DESIGN RF	DRAWN BY RF	<b>DART AEROSPACE LTD</b> HAWKESBURY, ONTARIO, CANADA	
CHECKED 	APPROVED 	DRAWING NO. DSI 9306	REV. A SHEET 1 OF 2
DATE 05.06.27		TITLE D412-705-015 INSTALL MOD	SCALE NTS
A	05.06.27	NEW ISSUE

## DART SERVICE INSTRUCTION

TO AMEND INSTALLATION INSTRUCTIONS IIN-D412-705 REV. A OR B

TO MAKE DART D412-705-015 DRIVE SHAFT TUNNEL MODIFICATION KIT COMPATIBLE WITH BELL P/N 212-061-903-177/-199 UPPER WEB ASS'Y, MODIFY THE INSTALLATION PROCEDURE AS SHOWN BELOW:

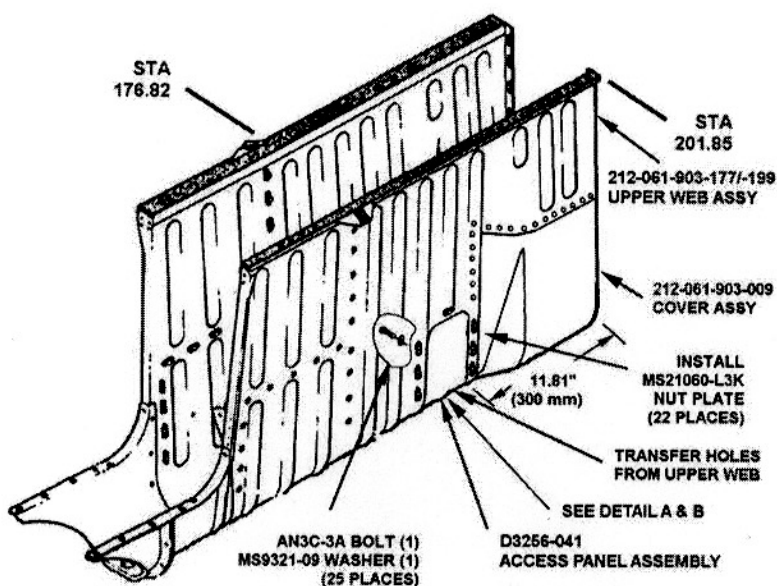
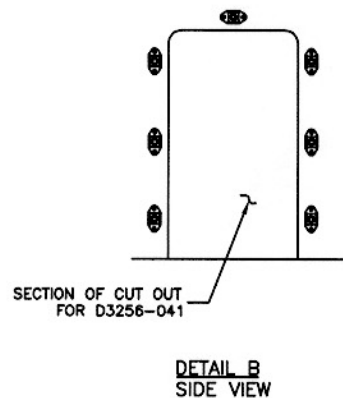
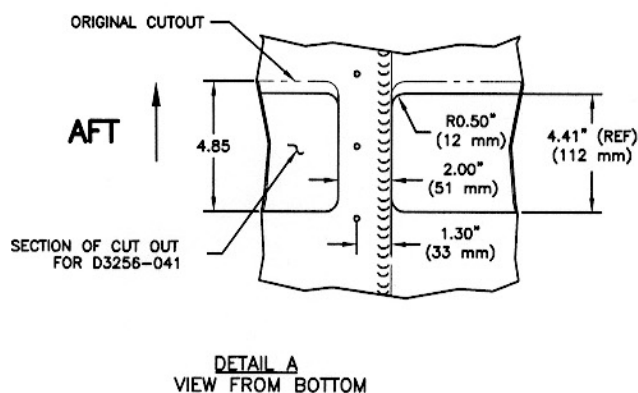
- 1) Remove P/N 212-061-903-177/-199 Drive Shaft Tunnel (Centerline Firewall) I.A.W. BHT-212 (412)-MM.
- 2) Position D3256-041 Access Panel Assembly inside Drive Shaft Tunnel as shown in Figure 1, with Tang facing aft in the bottom of the tunnel, ensuring that the panel follows the contours of the tunnel. The Aft edge of the untrimmed D3256-041 Access Panel should be 10.5" (266 mm) from the Aft end of the Drive Shaft Tunnel, or 9.88" (251 mm) from the Tang to the Aft edge. Mark the Drive Shaft Tunnel with the outline of the untrimmed Access Panel.

**Note: The Aft edge of the D3256-041 Access Panel will need to be trimmed to fit the PIN 212-061-903-177/-199 Tunnel and PIN 212-061-903-009 Cover Assembly. Do not transfer aft holes from Access Panel to Tunnel.**

- 4) Clamp D3256-041 Panel into Drive Shaft Tunnel ensuring seal contact around entire perimeter of access panel. Transfer the 10 holes from forward edge of the D3256-041 Access Panel Assembly and 2 top holes of the Access Panel to Drive Shaft Tunnel P/N 212-061-903-177/-199 with a #40 drill. **Note: do not transfer the aft holes from the Access Panel.** Match drill the 2 bottom holes from the Tunnel to the Access Panel.

- 5) Match drill from the Tunnel/Cover Assembly to the Access Panel, 10 holes through the existing empty rivet holes with a hole spacing pattern which most closely matches the forward Access Panel hole pattern.

- 6) Remove gasket from Aft end of Access Panel and trim approximately 0.44" (11.1 mm) from the Aft edge of the Access Panel. **Note: Ensure minimum edge distance of 0.300" (7.6 mm).** Reinstall the gasket over the new Panel edge and holes drilled in step 5.

- 7) Cut out two rectangular sections of the P/N 212-061-903-177/-199 Drive Shaft Tunnel, as shown in Figure 1, Detail A. **Note: No part of PIN 212-061-903-009 Cover Assembly is Cut.** Leave the center bottom section of the P/N 212-061-903-177/-199 Tunnel as shown in Detail A. Ensure cut out will leave a minimum edge distance of 0.30" (7.6 mm) from center of each hole to cut edge. Deburr the cut out. Dimple remaining rivet holes not used in step 5. Install MS20427M3 rivets where center bottom section of the P/N 212-061-903-177/-199 Tunnel attaches to the P/N 212-061-903-009 Cover Assembly.

- 8) Upsize the holes used for step 5 to  $\varnothing 0.204"$  ( $\varnothing 5.18$  mm) on Access Panel and P/N 212-061-903-009 Cover Assembly for clearance size on AN3 bolts. Install MS21060-L3K nut plates (22 places) using MS20427M3-3 rivets (use #40 drill 44 places) as shown in Figure 1.
- 9) Install D3256-041 Access Panel Assembly into Drive Shaft Tunnel using AN3C bolts provided. Use AN3C-3A bolts on the sidewalls and AN3C-4A bolts (2 places) on the bottom center locations. Ensure good fit between the Access Panel Assembly and the Drive Shaft Tunnel. Torque bolts to a maximum torque 25 in-lb (3 Nm).
- 10) Re-install modified Drive Shaft Tunnel I.A.W. B.H.T.-212 (412)-MM
